NEWMAR CORPORATION WARRANTY DEPARTMENT

TECHNICAL SERVICE BULLETIN																			
DATE ISSUED		MODEL YEAR(S) AFFECTED		MODEL(S) AFFECTED		TSB #													
7/3/08		2009		All DP		346													
BRAND						TYPE													
All	<input type="checkbox"/>	American Star	<input type="checkbox"/>	Mountain Aire	<input checked="" type="checkbox"/>	All	<input type="checkbox"/>	T T	<input type="checkbox"/>										
Cypress	<input type="checkbox"/>	Dutch Star	<input checked="" type="checkbox"/>	Kountry Aire	<input type="checkbox"/>	F W	<input type="checkbox"/>	C A	<input type="checkbox"/>										
Northern Star	<input type="checkbox"/>	Dutch Aire	<input checked="" type="checkbox"/>	Essex	<input checked="" type="checkbox"/>	D P	<input checked="" type="checkbox"/>	D B	<input type="checkbox"/>										
Scottsdale	<input type="checkbox"/>	King Aire	<input type="checkbox"/>	London Aire	<input type="checkbox"/>														
All Star ME	<input checked="" type="checkbox"/>	Ventana	<input checked="" type="checkbox"/>	Bay Star	<input type="checkbox"/>

CAMPAIGN SERVICE BULLETIN

SUBJECT: Low Voltage Power Distribution – Spartan Control Module (SCM)

FIG. 2-1

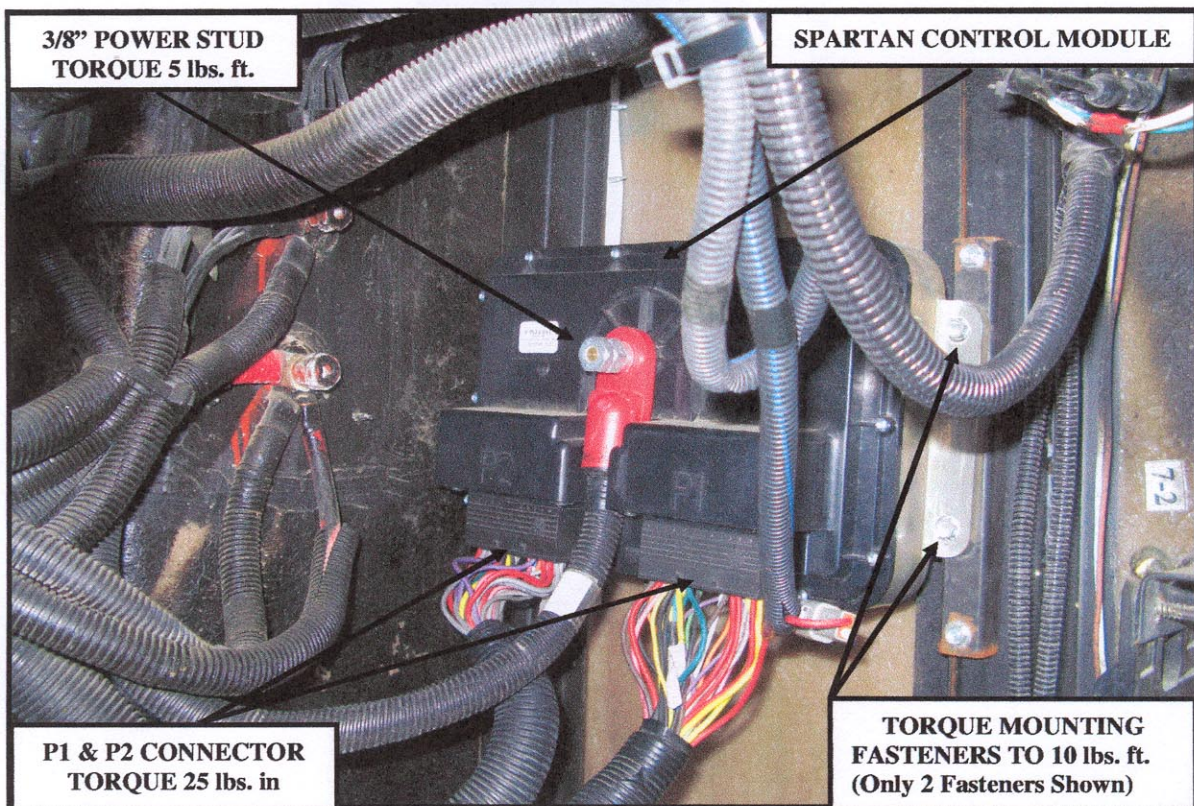
1. Observe all industry safety standards, disconnect any necessary power source and secure vehicle for replacement of Spartan Control Module (SCM).
2. Locate main disconnect switch, normally installed on rear bulkhead in engine compartment, switch to the "off" position.
3. Refer to FIG. 2-1. Locate SCM in driver side front compartment or under front hood.

4. Refer to FIG. 2-1. Remove main power lug from 3/8" stud on SCM, retain nut for reuse.
5. Refer to FIG. 2-1. Remove two (2) connectors labeled P1 & P2 from SCM.
6. Refer to FIG. 2-1. Remove SCM from mounting location, retain mounting hardware for reuse. Properly dispose of control module.
7. Install new SCM (Rev.E) from kit, using hardware retained from previous steps. Torque to 10 lbs. ft.
8. Refer to FIG. 2-1. Reinstall both connectors (P1 & P2). Torque to 25 lbs. in.
9. Refer to FIG. 2-1. Reinstall main power cable to 3/8" power stud. Torque to 5 lbs. ft.
10. Reconnect any power source previously disconnected.
11. Return main power switch to the "on" position.

CORRECTION: Replace SCM with Revision E
